TO: Mercedes-Benz Dealer Principals, General Managers, Sales Managers, Service Managers, Parts Managers	FROM: Gregory Gunther, Senior Manager, Vehicle Compliance and Analysis, Engineering Services
RE: <b>Service Campaign Launch Notification</b> <b>Inspect Weld Seam on Trunk Lid for Crack</b> <b>MY23 C-Class (206 platform)</b>	DATE: February 16, 2024

Campaign No. 2024010016, February 2024

SUBJECT: **Model C-Class (206 platform)**  
**Model Year 2023**

## **Inspect Weld Seam on Trunk Lid for Crack**

Figure 1

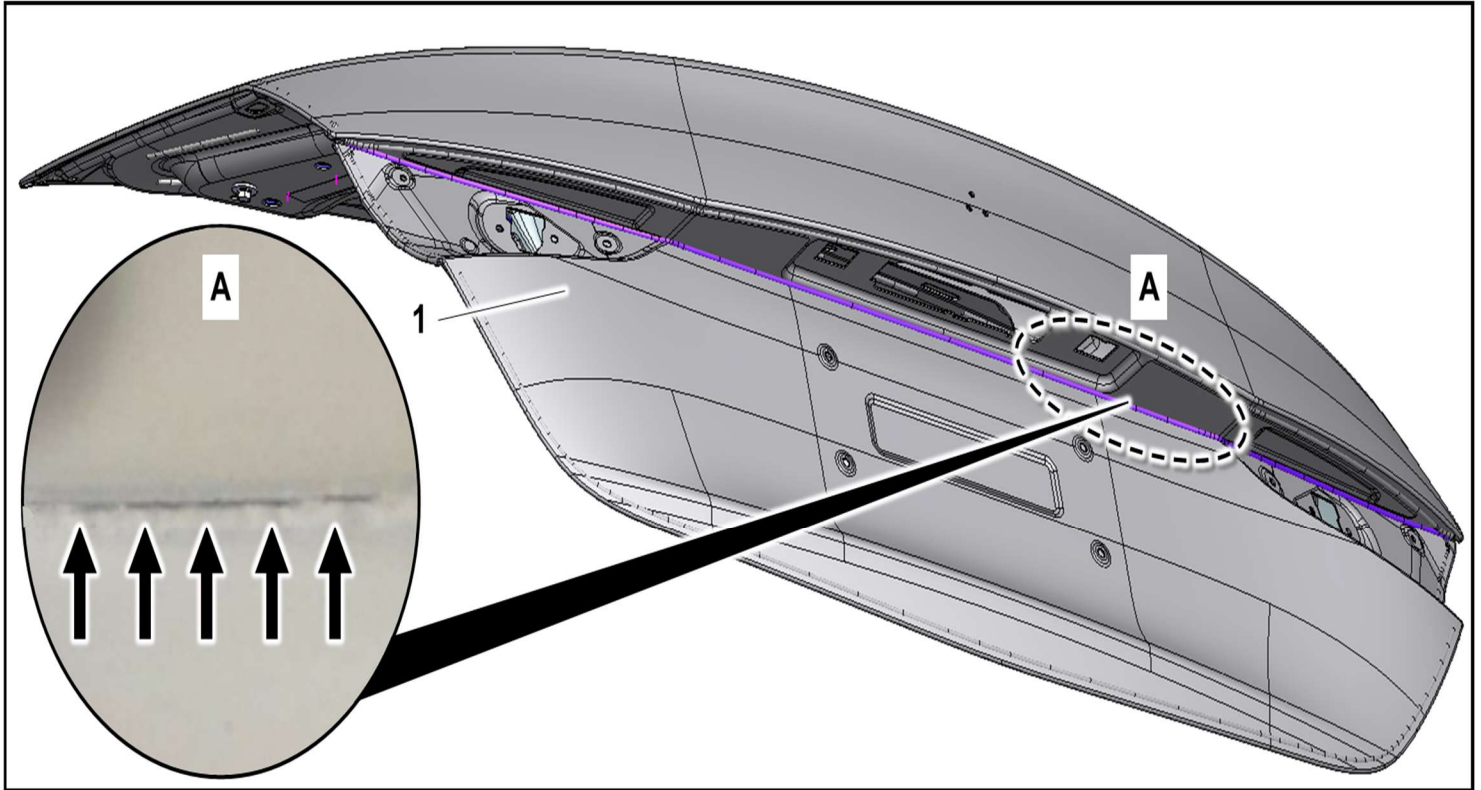
Mercedes-Benz AG (“MBAG”), the manufacturer of Mercedes-Benz vehicles, has determined that on certain MY 2023 C-Class (206 platform) vehicles, the weld seam on the trunk lid may not meet current production specifications. It is possible that a crack may be evident on the weld seam. An authorized Mercedes-Benz dealer will inspect the weld seam on the trunk lid and replace the trunk lid, if necessary.

1. Inspect the weld seam on trunk lid (**Figure 1, 1**) at the depicted location (**Figure 1, A**) for a possible crack.

**i** Weld seam must be checked in the direction of travel of weld.

- a. **Crack is** visible on trunk lid (**Figure 1, 1**) at specified location (**Figure 1, A**) – Carry out **Work Procedure**.
- b. **No crack** visible on trunk lid (**Figure 1, 1**) at specified location (**Figure 1, A**) – **End Measure**.

1. Replace trunk lid (**Figure 1, 1**).
